Haley Rich - Submission objecting to Jacfin Horsley Park project 10_0129 and 10_0100 - Revised attachment

Proposed Employment Land Development

Jacfin, Burley Road, Horsley Park Project

Re: Jacfin Horsley Park Industrial Estate Project Application

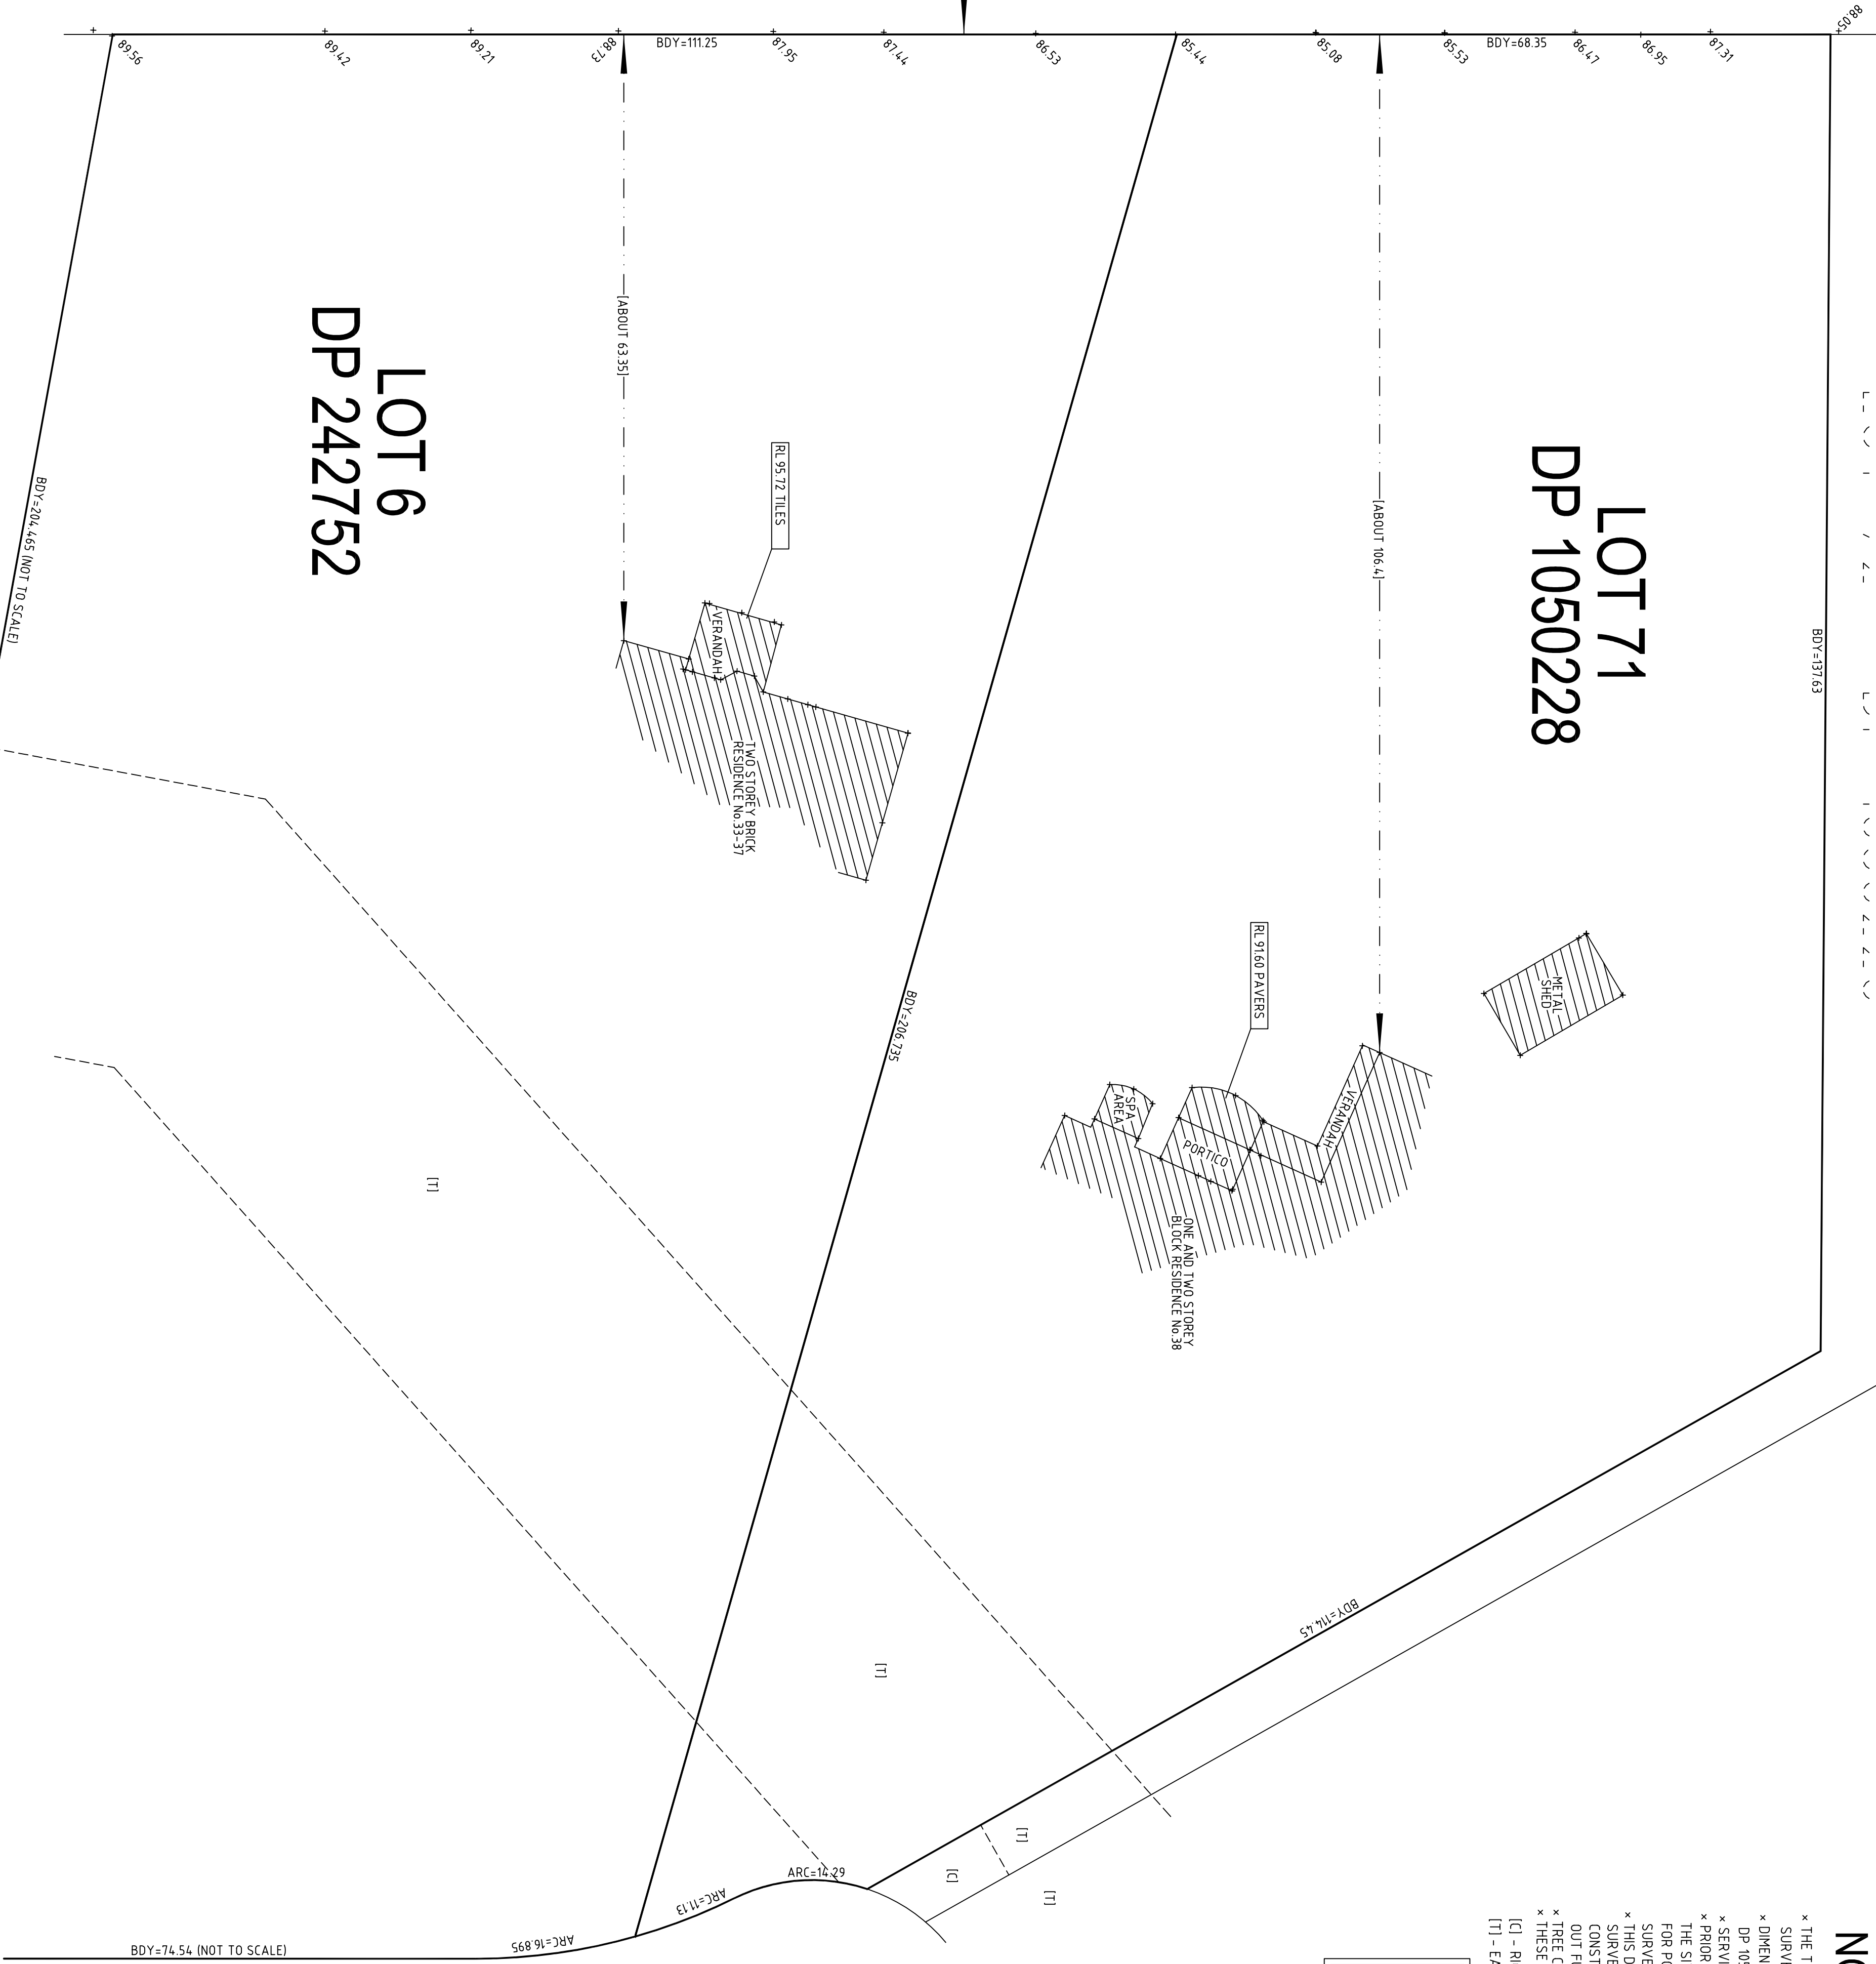
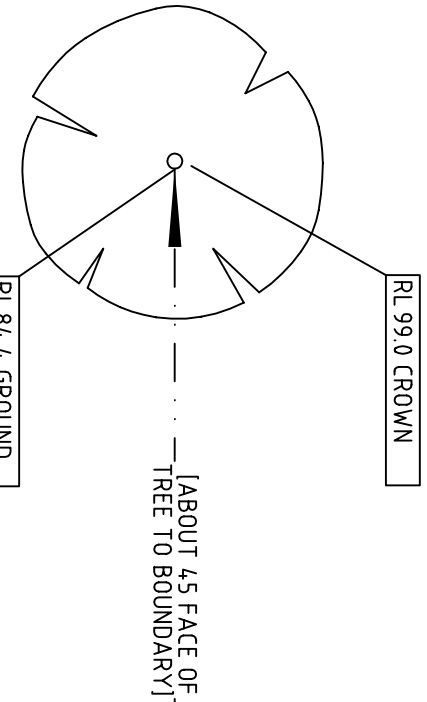
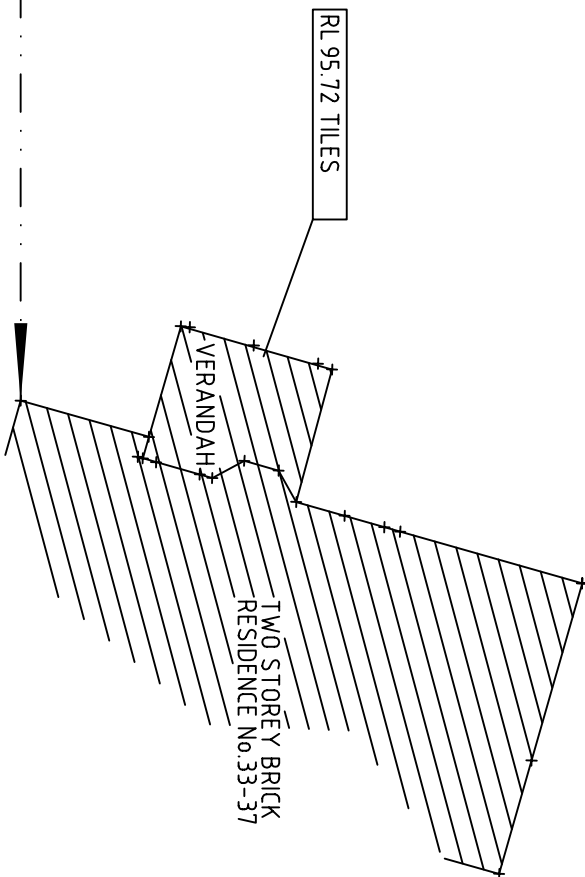
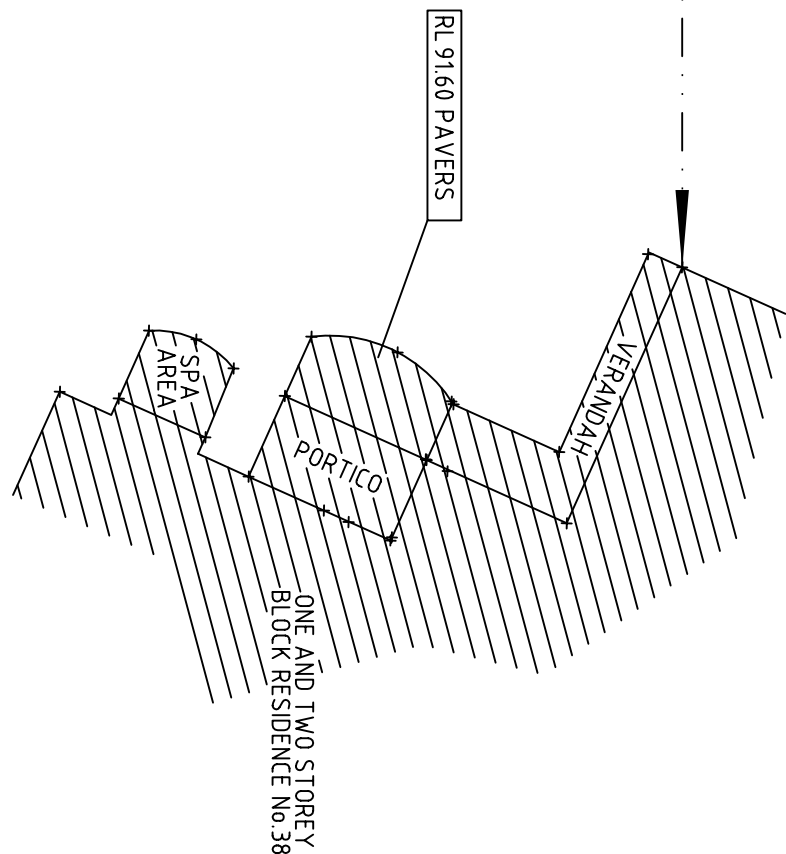
The attached survey plan by T Grabara and Associates shows the floor levels of primary living areas of each of my clients' properties. As a guide to what the likely effect on their views will be, the location and height of a prominent residual ironbark tree in the subject land was also surveyed. The tree is visible in the photographs attached, which depict views from inside each property.

The rear terrace of the McHale residence has a level of RL 91.60. The building pad for the nearest building has an approximate level of RL 85. The base of the tree in the photographs and on the survey is at RL 84.4 and it has a canopy height of approximately RL 99.0, giving a height above natural ground level of approximately 14.6m.

The rear verandah of the Micallef residence has a level of RL 95.72. The Micallef residence has a more expansive view in a horizontal sense than the McHale enjoy. As before, the building pad of the nearest building is at approximately RL 85.

CP009 Concept Plan

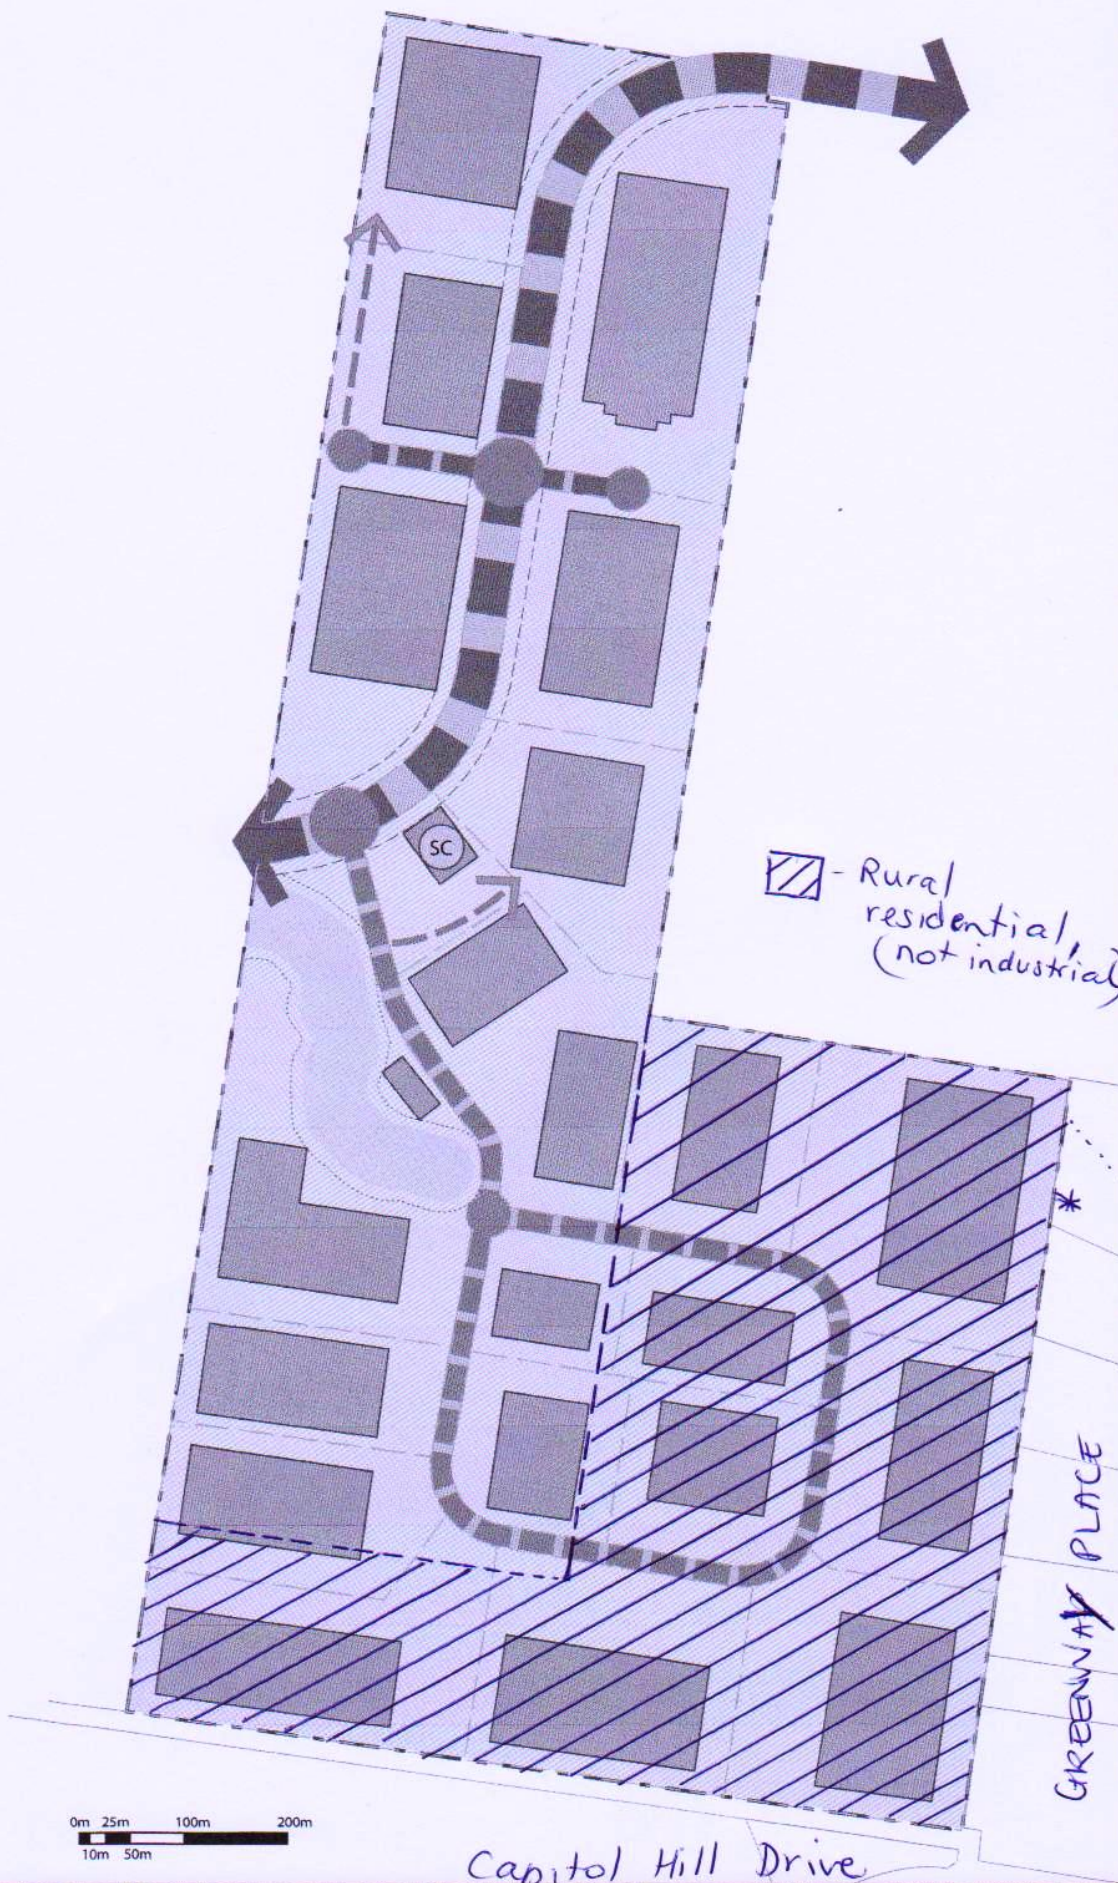
There should be a buffer zone between the factories/warehouses and the eastern and southern residential boundaries. The area in front of residents (marked on Attachment 1) should instead be utilised for rural residential blocks. This would provide a buffer to existing residents and would be consistent with the existing landscape, heights and character of the surrounding residential areas, as per Section 23 of the SEPP.

- Provide a buffer zone between the residential properties and the industrial estate, in line with the quarry boundary (as marked on Attachment 1). Consider using this land for rural residential subdivision, to minimise costs associated with open space for the landowner. These blocks could be sold with a caveat indicating that owners cannot object to future industrial buildings, provided that they comply with the relevant DCP and SEPP (WSEA) 2009.
